BRUCE H HAMILTON
Vice President
McGuire Nuclear Station

Subject: Duke Energy Carolinas, LLC (Duke)
McGuire Nuclear Station, Units 1 and 2
Docket Nos. 50-369 and 50-370

Response to Request for Additional Information related to
the License Amendment Request for Implementation of
Alternative Source Term.

ATTACHMENT 1

PLOT PLAN FOR
CONTROL ROOM HABITABILITY
ASSESSMENT

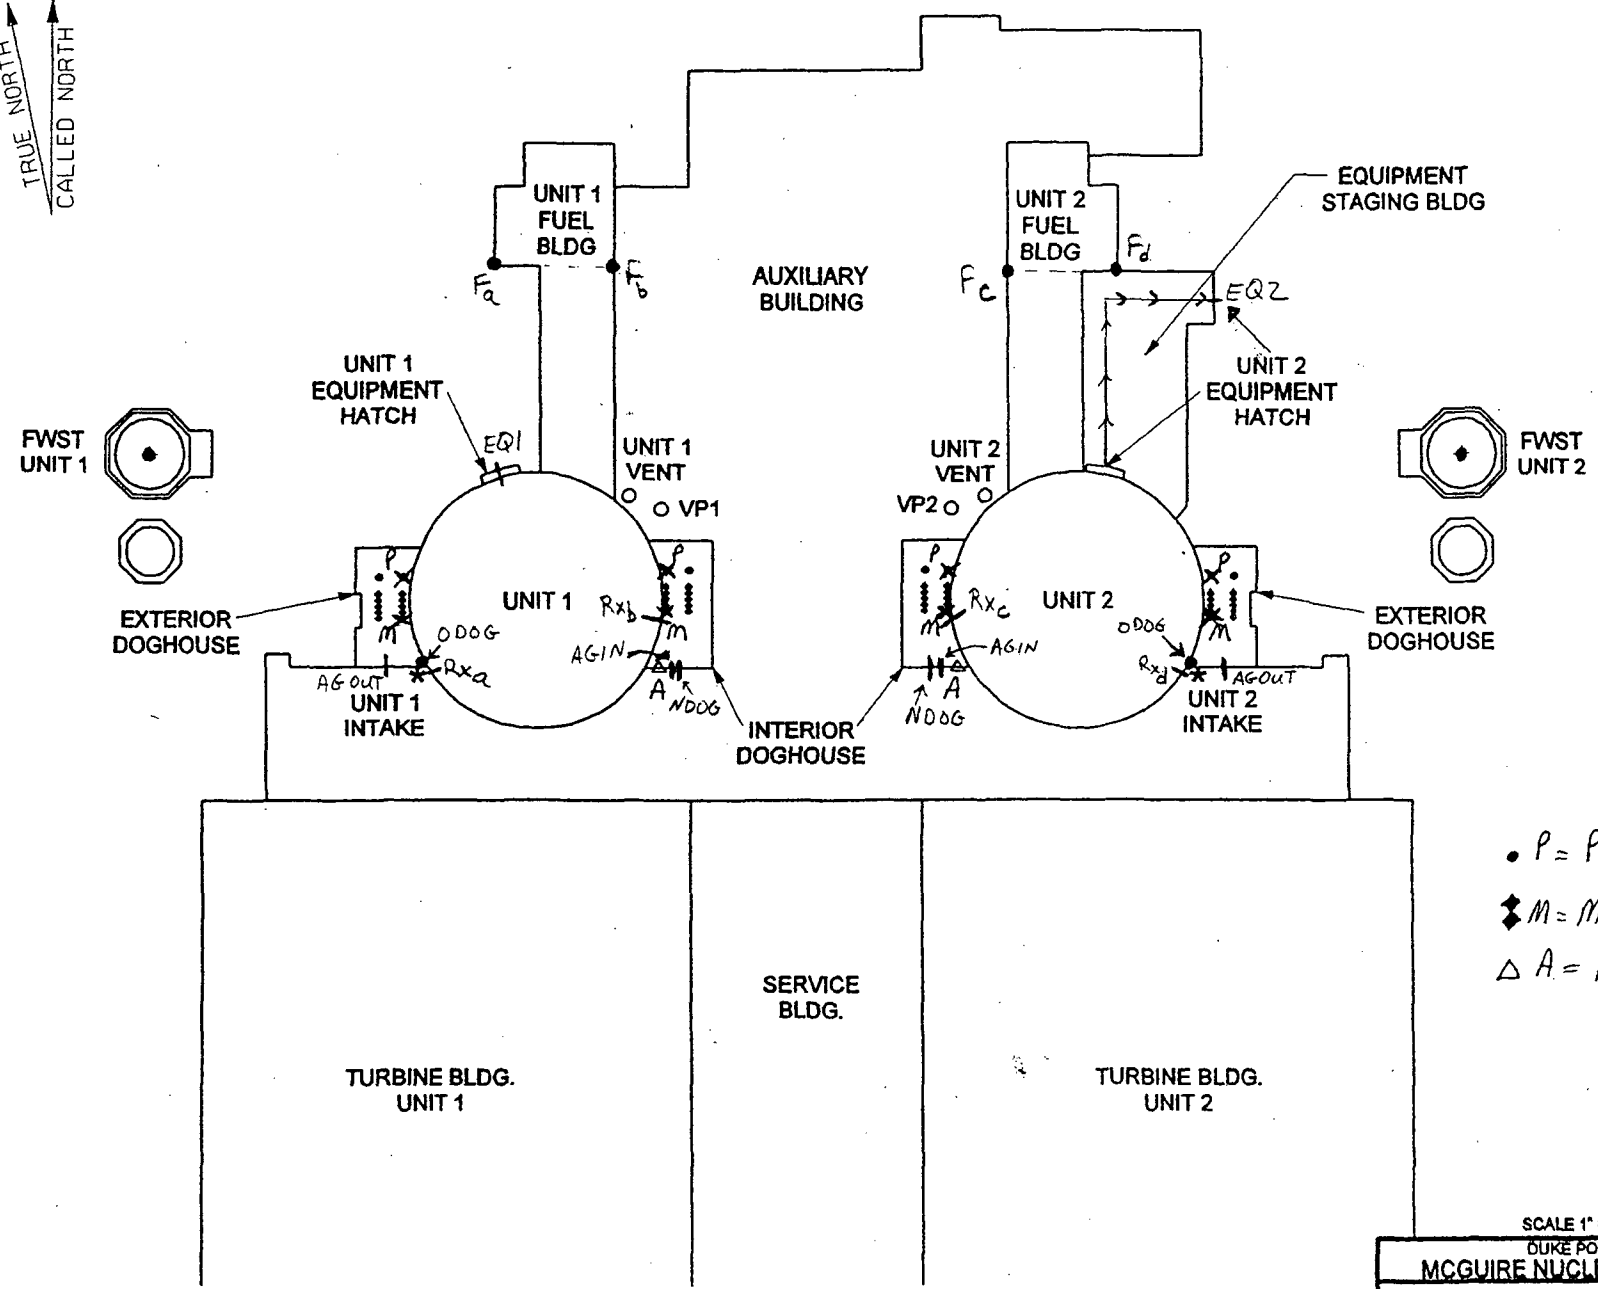
Is the Appendix A drawing of the March 20, 2008 LAR drawn to scale? If so, please provide the scale used for the drawing. Are all of the postulated release locations applicable to this LAR clearly highlighted to enable NRC staff to make confirmatory estimates of the selected inputs and assumptions? If not, please highlight all postulated release locations on a revised scale drawing and provide to NRC staff.

Yes, the plant sketch that was included in Appendix A to the original LAR submittal (Reference 2) was drawn to scale (originally 1"=100 ft), but it is not an "engineering drawing." Also, the figure supplied with the original LAR submittal (Reference 2) was not scanned to full original size so application of the scale to that sketch would not have been appropriate. Thus, both the original sketch and the marked-up version attached in Appendix B of this response should be treated as approximate, since they (a) are largely based on McGuire Nuclear Station "fly-over" data (Microstation format) with uncertainties inherent to aerial surveys, (b) have been reproduced by scanning and via copy machines, and (c) the updated sketch includes source locations plotted by hand. To verify the scale, note that the diameter of each reactor building (Unit 1 and Unit 2) is 130 feet.

Straight-line distances and directions used in the calculation were determined from station drawings and cross-checked with photos made during a station walk-down in the year 2000. They were also checked during the creation of the original Microstation figure from the fly-over's digitized data. Arc-length distances were measured using Microstation software tools.

Exact locations of all of the sources were not shown on the figure in Appendix A of the original LAR (Reference 2). A marked-up version of that sketch is included as Appendix B of this response. It should be used by applying the scaling to estimate distances. The locations of the all sources have been clarified on the sketch in Appendix B of this response package, as described below:
